**Re: Major Modification to the Operable Unit 1 Corrective Action
Decision/Record of Decision**

MAJOR MODIFICATION
TO THE
OPERABLE UNIT 1: 881 HILLSIDE AREA
CORRECTIVE ACTION DECISION/RECORD
OF DECISION

**MAJOR MODIFICATION TO THE
OPERABLE UNIT 1
CORRECTIVE ACTION DECISION/RECORD OF DECISION**

Figure 2. Well 0487 Trichloroethene Concentrations.

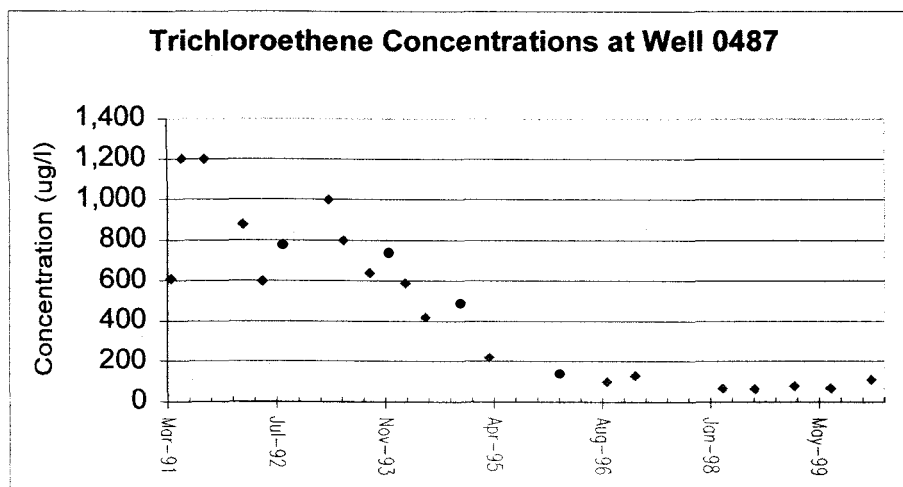
Comment: A correlation of Trichloroethene (TCE) concentrations to the water table levels reflected in the OU1 collection well needs to be completed. Such a graph would give a more complete picture of the TCE values relative to the water table. There is a possibility that the natural ebb and flow of the underlying water table could directly impact the TCE concentrations. Breaching the French Drain before the water balance study is complete would be premature. Removing the Drain eliminates a line of defense for surface water and emphasizes the need to include an evaluation of impacts to surface water.

Data from the downgradient well located between the Collection Well and the French Drain, also show a strong downward trend. These data are now included in the CAD/ROD Modification. Data from the French Drain show that, even with variations in TCE concentrations in the Collection Well, contaminant concentrations are consistently below Tier II action levels in the French Drain and the water quality is not impacted by the upgradient contamination. Therefore, the French Drain is not required as a line of defense to protect surface water. The Collection Well will remain in place, and if required, could be immediately returned to service. Additional information documenting the lack of impact to surface water was added to the OU1 CAD/ROD Modification.

Figure 3. OU 1 Collection Well Trichloroethene Concentrations and Projection.

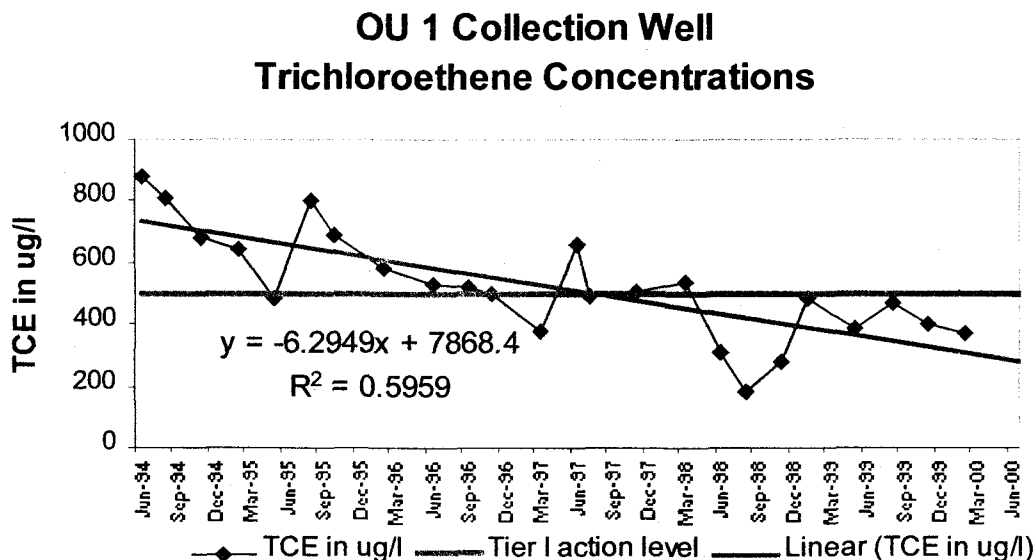
Comment: The declining trend identified in Figure 1 is not reflective of statistical means, nor does the figure correlate concentrations to dry seasons or wet seasons. Figure 1 reflects a linear regression, not a statistical regression; therefore, Tier I levels may be exceeded in the future. Broomfield agrees with the EPA's recommendations to continue collection of the groundwater to reduce the concentration of TCE to a level approximating the Tier II groundwater value. The City of Broomfield recommends collection and treatment of groundwater to continue until Tier II values are achieved for a continuous two-year period to ensure concentrations of TCE are stable and below Tier I levels during wet seasons. Continuing the treatment and removal of TCE ensures there will be protection of surface water standards. DOE assumed natural attenuation will occur, therefore reducing the impact to surface water. DOE also assumes the linear regression model accurately represents the system, but seasonal precipitation is a variable that is not factored into the linear regression model. What modeling was used to confirm surface water would not be impacted at levels two orders of magnitude or less? Broomfield would appreciate the opportunity to review the modeling performed.

Comment: The simple linear regression of TCE concentrations over time as noted in Figure 1 (OU1 Collection Well Trichloroethene Concentrations Projections) shows the r-squared value of 0.5959. A value that was closer to 1 would provide greater confidence that a declining trend was indeed occurring. Rather than relying on an assumption that natural attenuation is taking place, and that the linear regression model accurately reflects the system, DOE is strongly encouraged to maintain the system for three more years in order to obtain better statistical data to prove that the trend is actually occurring.

There are declining concentrations at both the Collection Well and the downgradient well. As noted, there are seasonal variations in the TCE concentrations at the Collection Well. However, even with these variations, contaminant concentrations are consistently below Tier II action levels in the French Drain. This evaluation, now included in the modification, shows that there is no impact to surface water.

Response: The simple regression was based on data available since the Collection Well was installed in 1992 and indicates a general declining trend but also shows seasonal and weather-related variability. A regression based on the average annual concentrations resulted in an r-squared value of 0.82 corroborating the declining trend. In addition, when data from the Collection Well were segregated by quarter, to eliminate seasonality, each quarter's results also show strong declining trends.
